Addendum #3 - Bid Package #6929-07

Project Name: Lincoln Public Schools District Office
5901 'O' Street
Lincoln, NE
Project No.: 11065
Issued: August 17, 2012

Sketch A1
 Bid Package 6929-07
 Addendum 03
 Modification to K1/A105

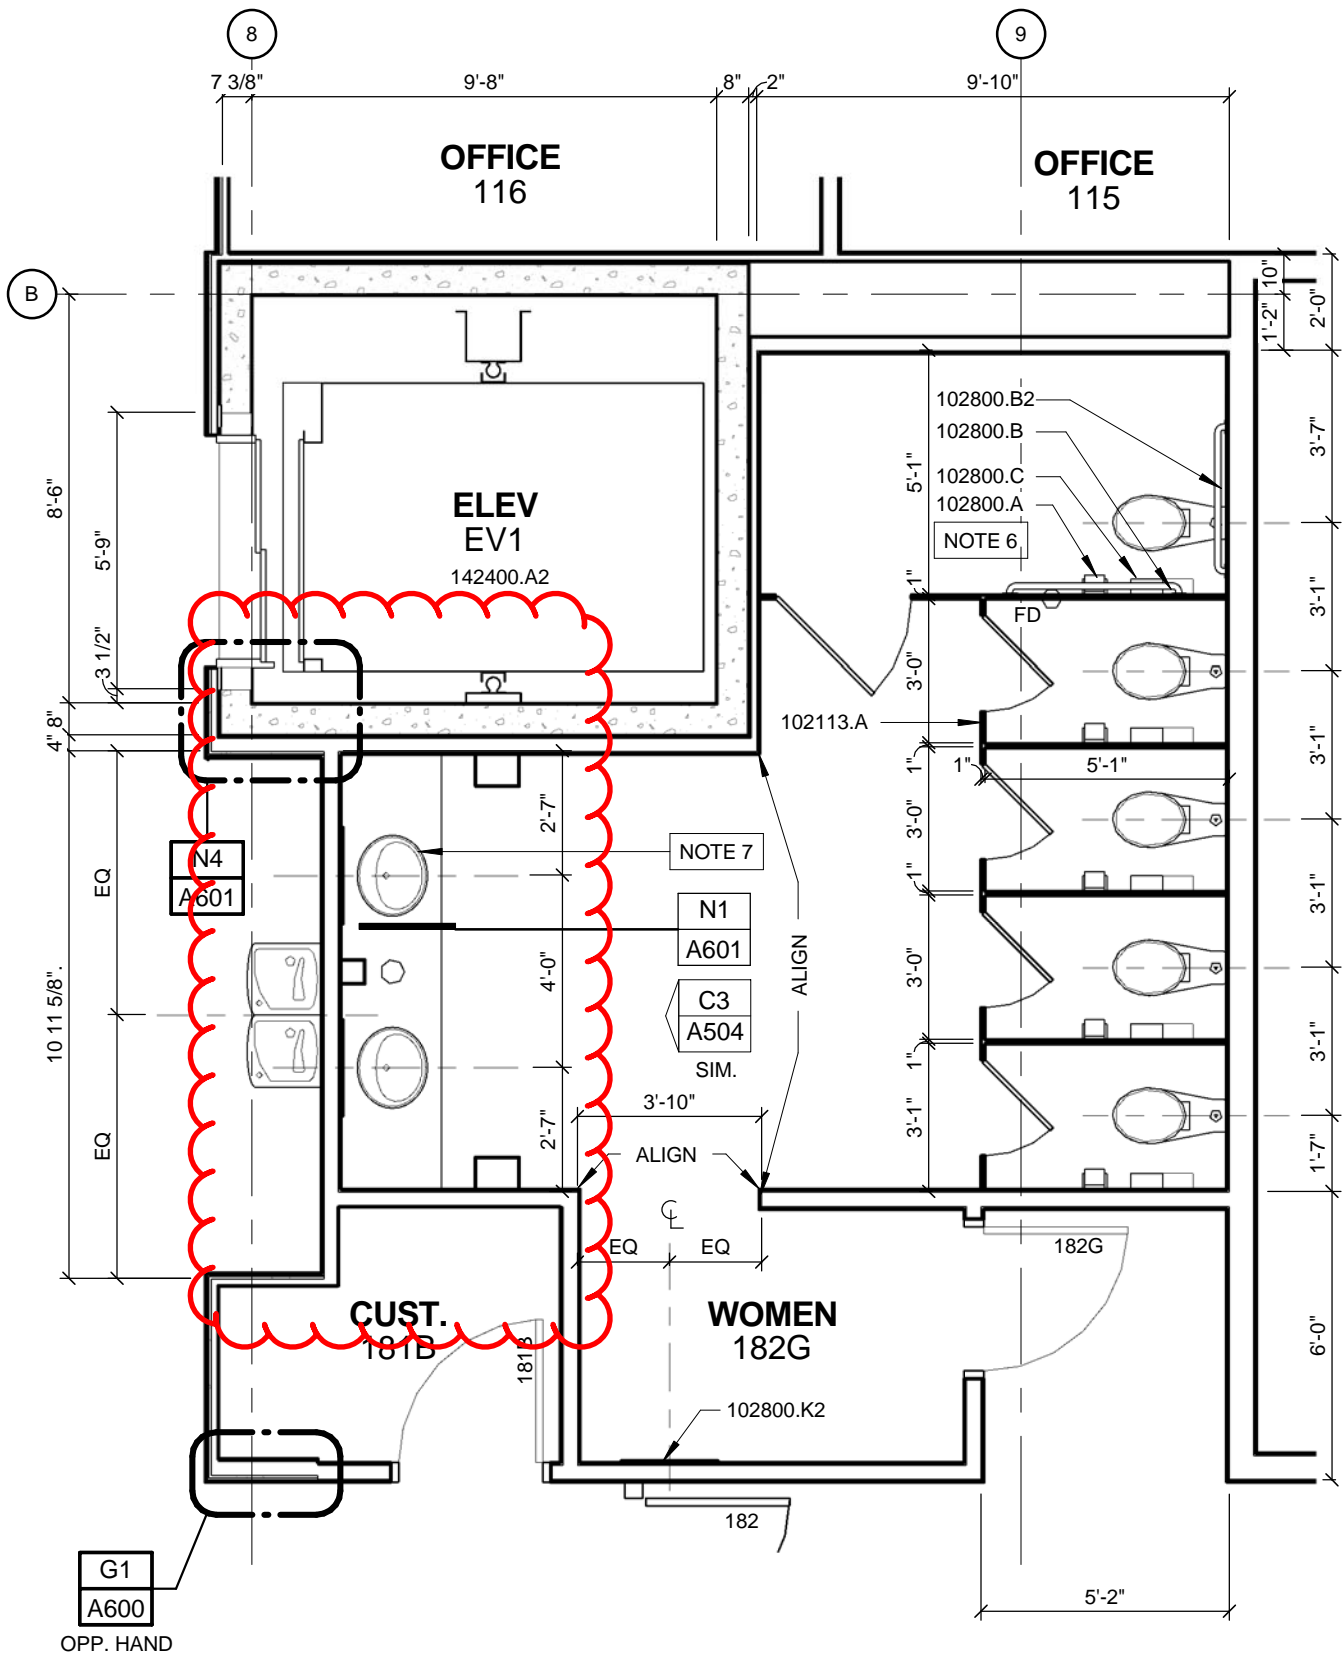
- ADD 3-6.** Refer to K1/A105; One lav has been removed from restroom layout. Refer to attached **Sketch A1**.
- ADD 3-7.** Refer to K4/A105; One lav has been removed from restroom layout. Refer to attached **Sketch A2**.

Sketch A7
 Bid Package 6929-07
 Addendum 03
 New Detail N1/A601

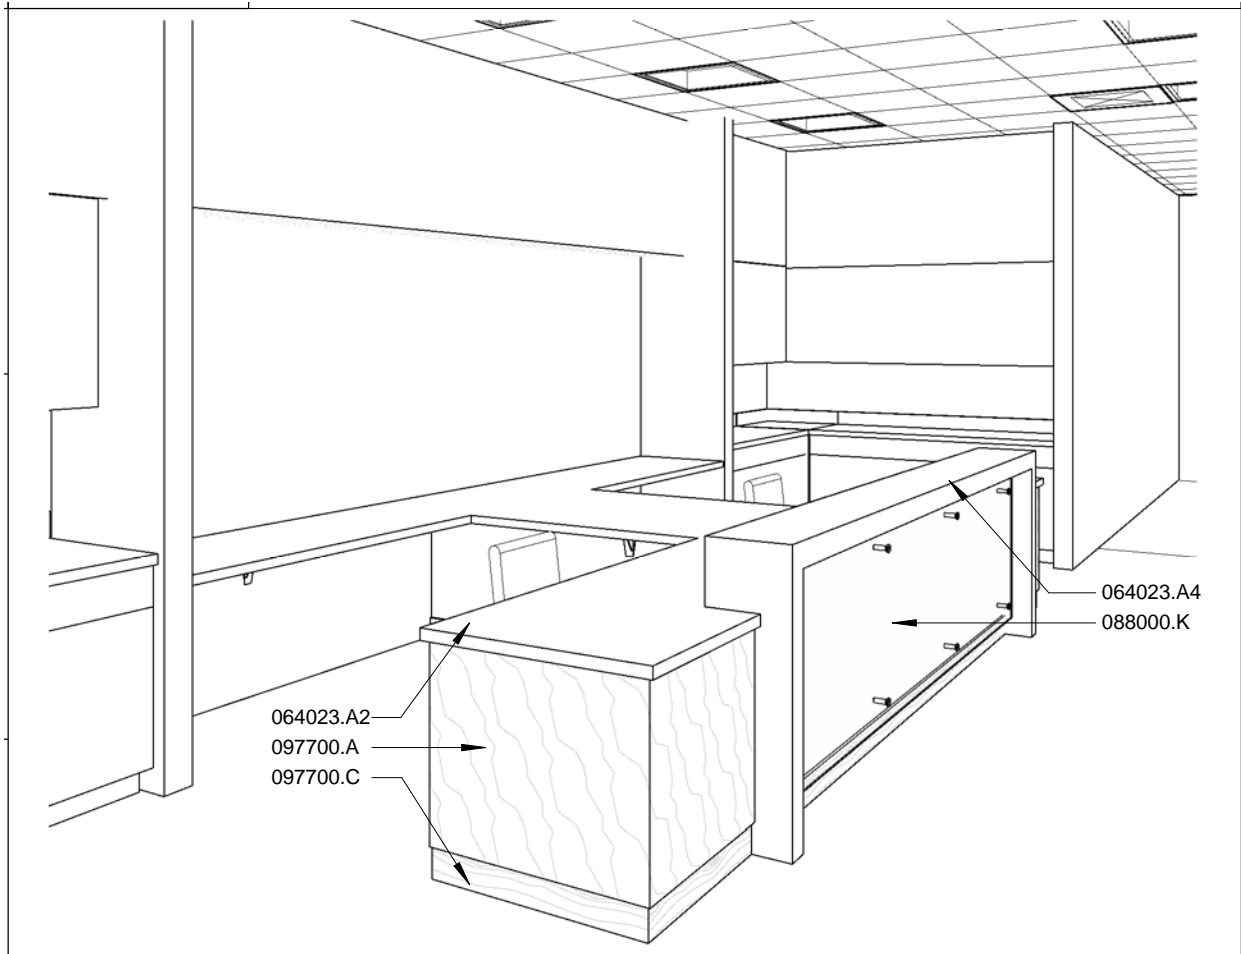
- ADD 3-12.** Refer to Sheet A601; Add Detail N1. Refer to attached **Sketch A7**.
- ADD 3-13.** Refer to Sheet A601; Add Detail K1. Refer to attached **Sketch A8**.

Sketch A8
 Bid Package 6929-07
 Addendum 03
 New Detail K10/A601

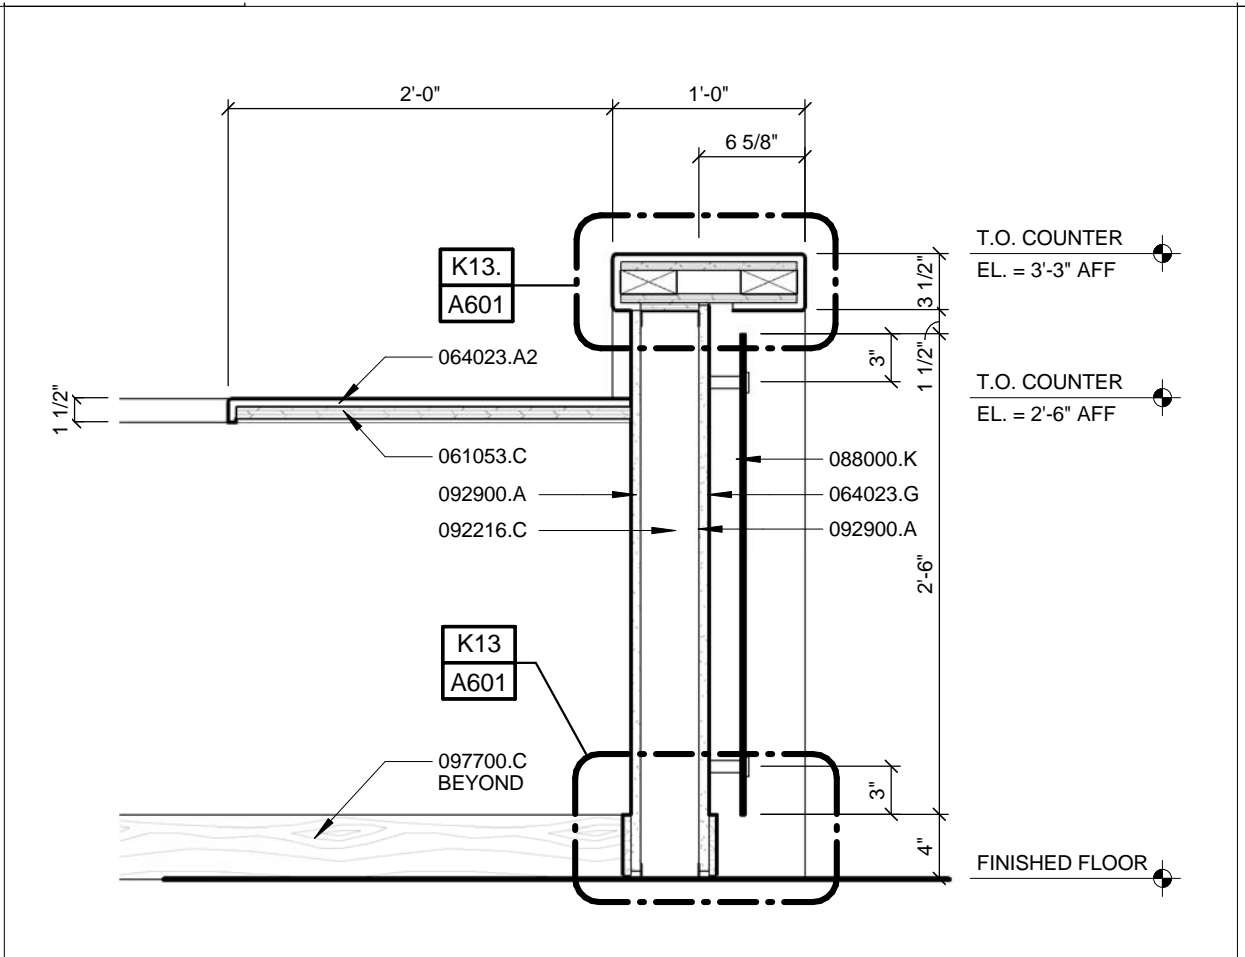
- ADD 3-14.** Refer to Sheet A601; Add Detail K10. Refer to attached **Sketch A9**.
- ADD 3-15.** Refer to Sheet A601; Add Detail K13. Refer to attached **Sketch A10**.

Sketch A10
 Bid Package 6929-07
 Addendum 03
 New Detail K13/A601

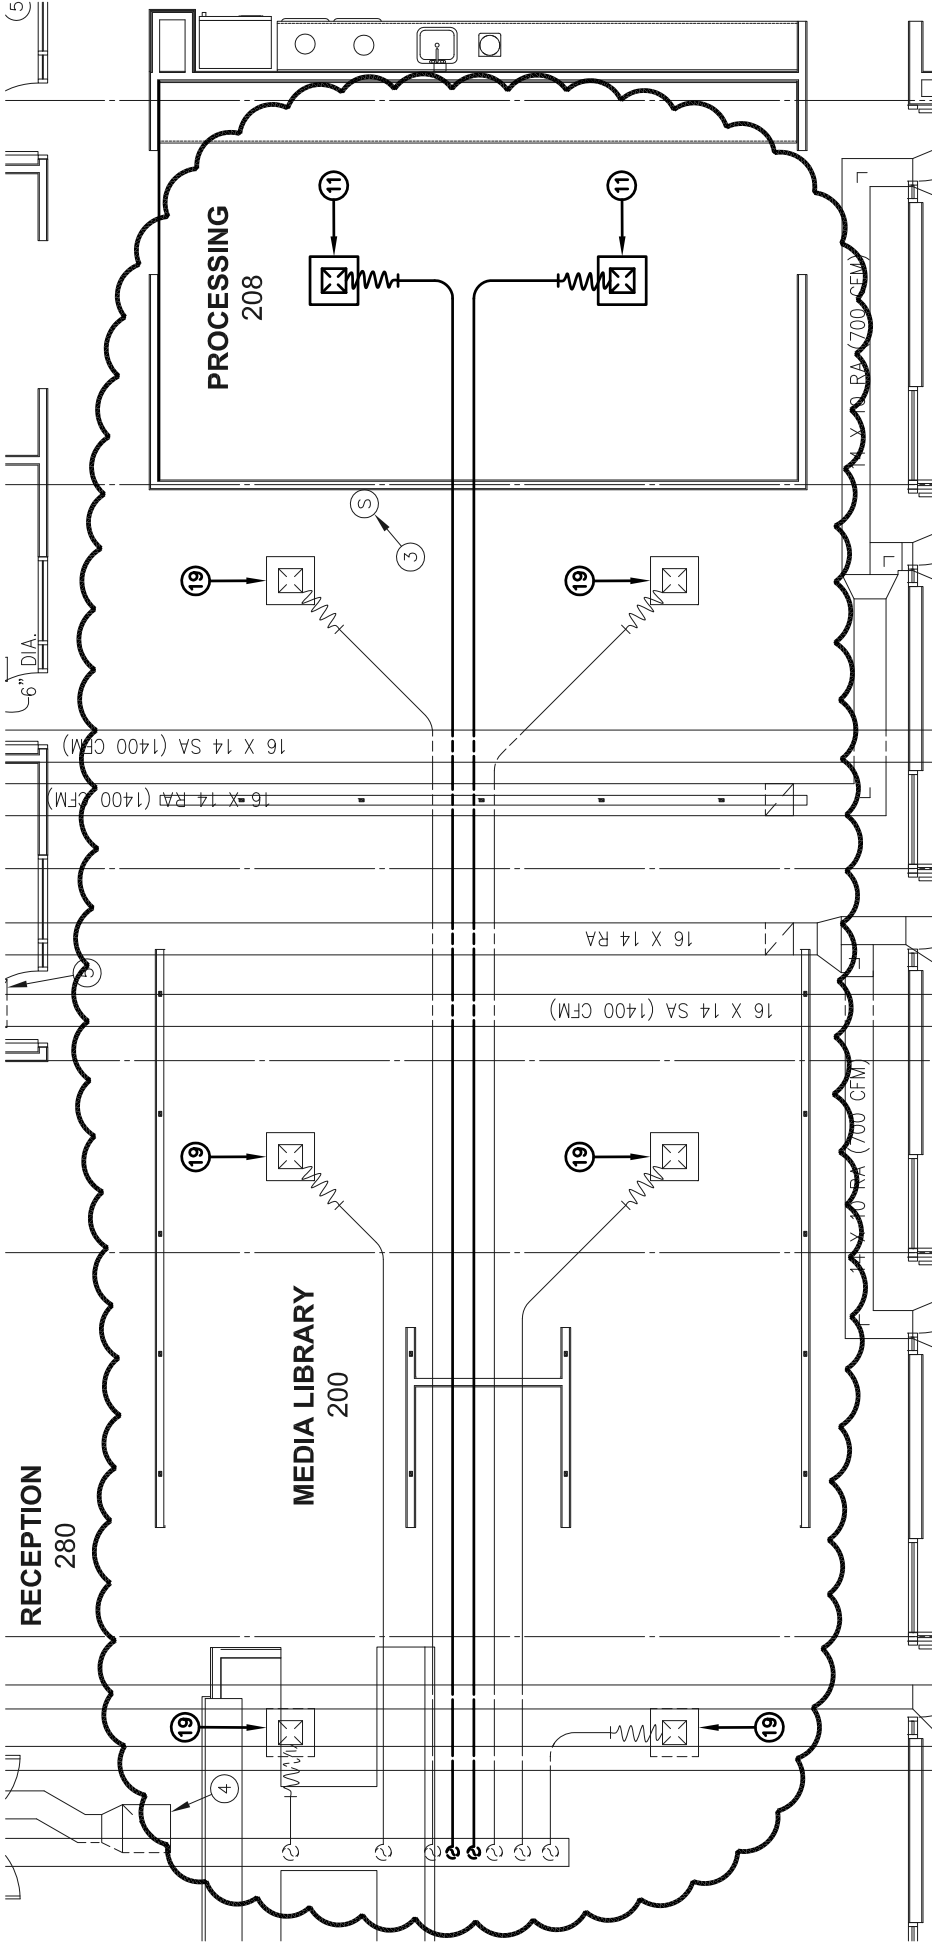
ADD 3-19. Refer to Sheet M202 – Second Floor HVAC Plans

- A. Add two diffusers to Processing 208 and revise CFM values to diffusers serving Media Library 200. See **attached drawing M1**.

- 11. 6" DIA. CEILING DIFFUSER (CD), 100 CFM. EXTEND 6" DIA. DUCT AS SHOWN.
- 19. 6" DIA. CEILING DIFFUSER (CD), 130 CFM. EXTEND 7" DIA. DUCT AS SHOWN.

08/17/12
SHEET
ME001
ATTACHMENT NO.
EI
BJF

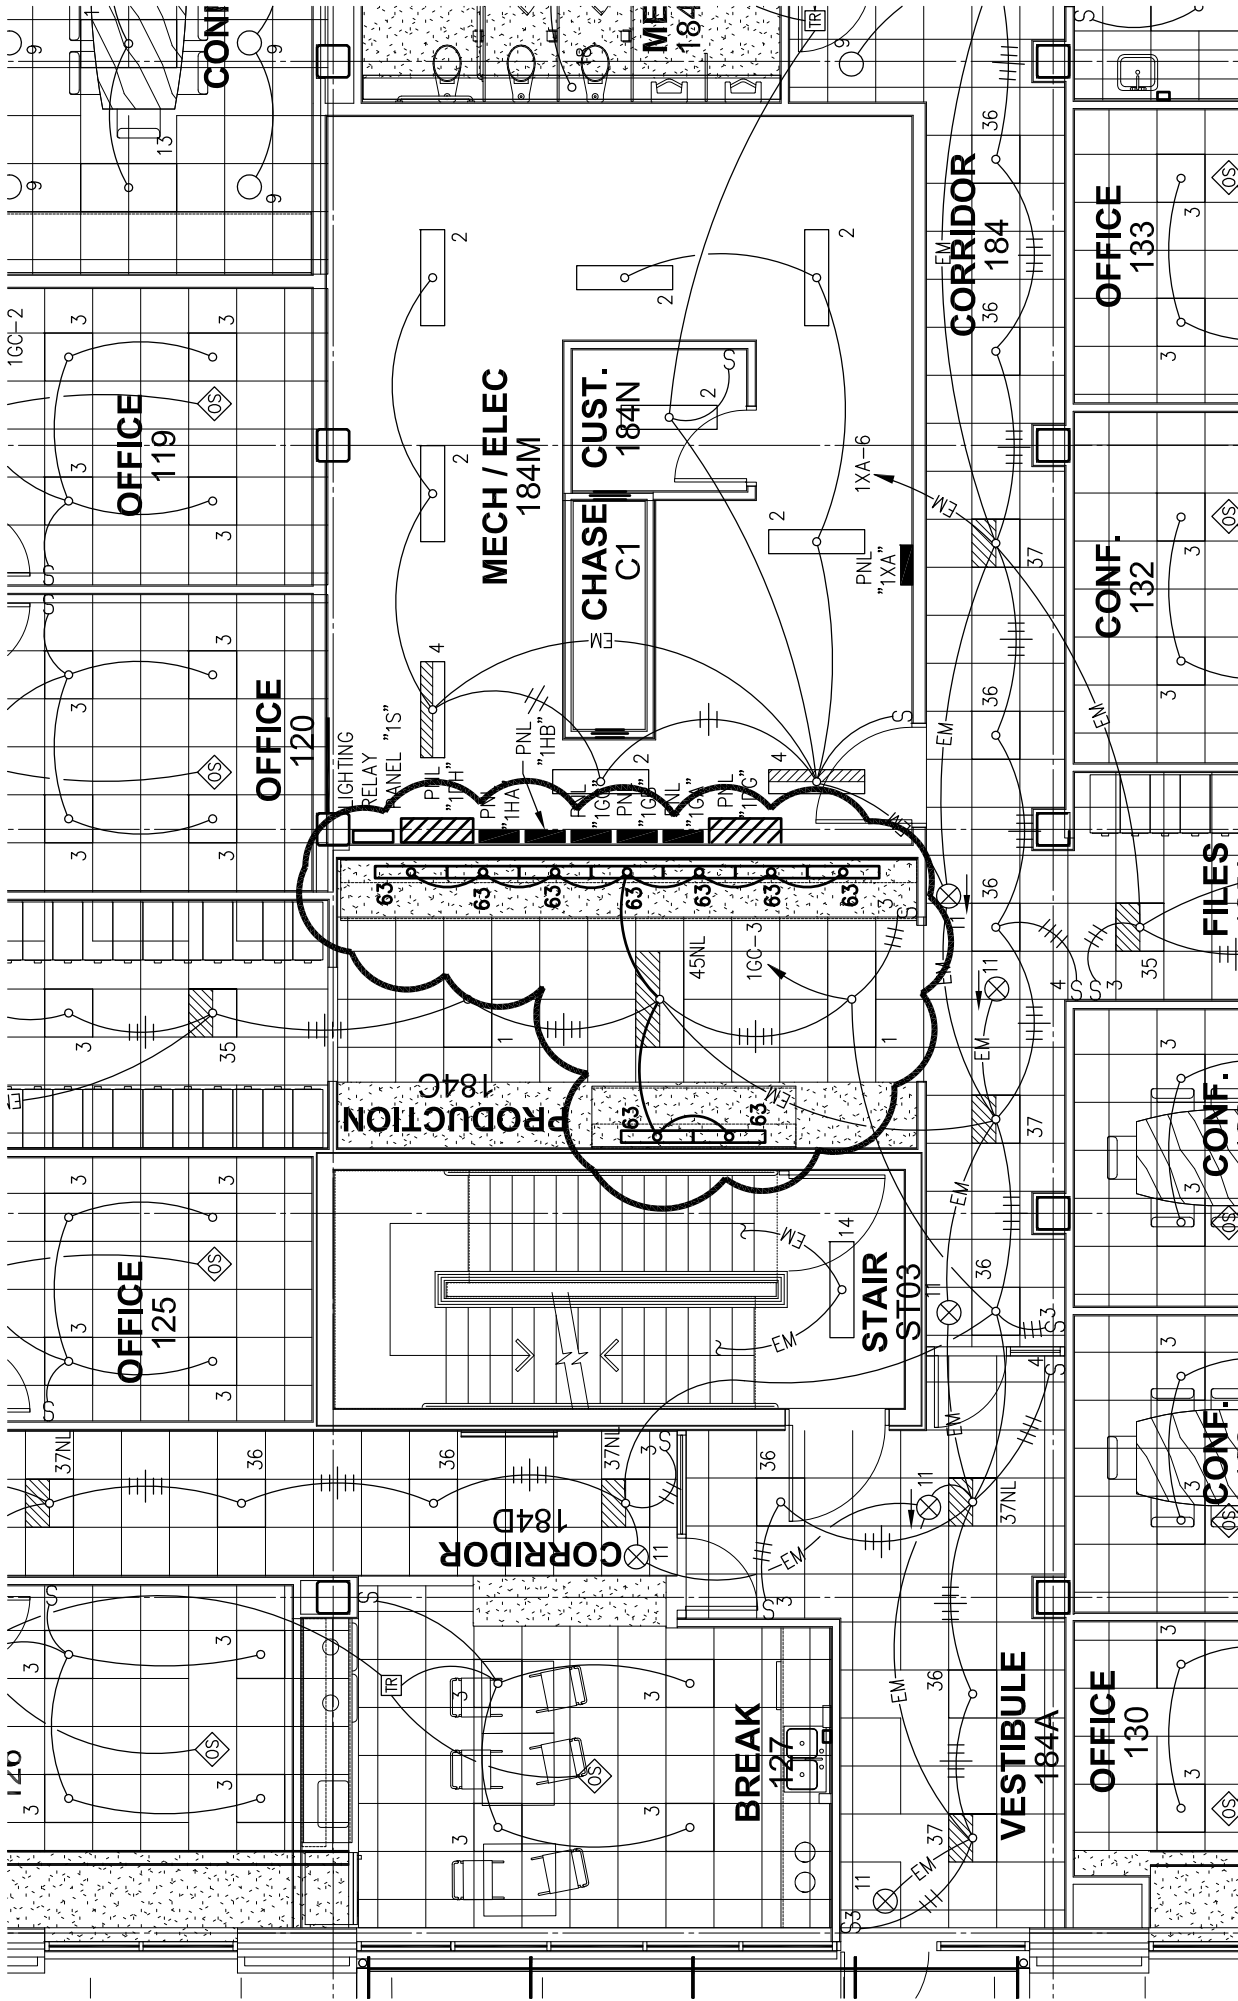
ADD 3-22. Refer to Sheet ME001 Site Plan – Mechanical and Electrical

- A. There is a light fixture that is not labeled at the southwest corner of the Retail building. This shall be a Type 28. This will make a total of 14 Type 28 light fixtures around the Retail and Whole Foods buildings. See **attached drawing E1**.
- B. Move Light Fixture Type 26 that is located at the handicap parking stall in front of Whole Foods 4-feet to the south. See **attached drawing E1**.

08/17/12
SHEET
E101
ATTACHMENT NO.
E2
BJF

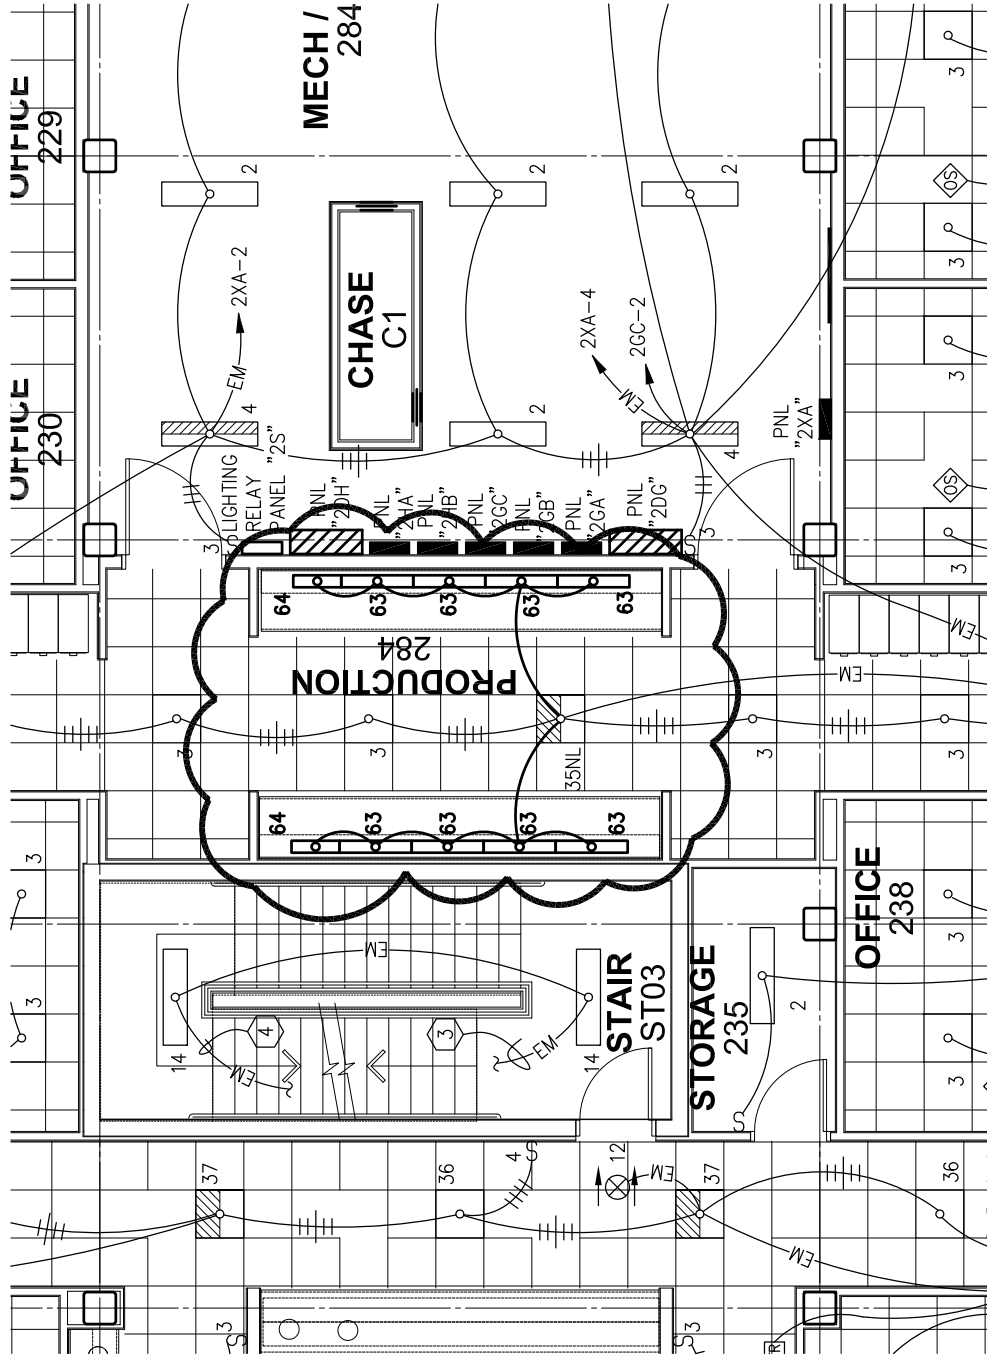
ADD 3-23. Refer to Sheet E101 – First Floor Plan – Lighting

- A. Change Light Fixture 35NL to Type 3NL, (delete bodine transfer device). Light fixture shall still be connected to emergency circuit and shall be unswitched.
- B. Change Light Fixture 37NL to Type 36NL, (delete bodine transfer device). Light fixture shall still be connected to emergency circuit and shall be unswitched.
- C. Change Light Fixture 45NL to Type 1NL, (delete bodine transfer device). Light fixture shall still be connected to emergency circuit and shall be unswitched.
- D. Provide under cabinet lighting as indicated. See **attached drawings E2 and E3**.
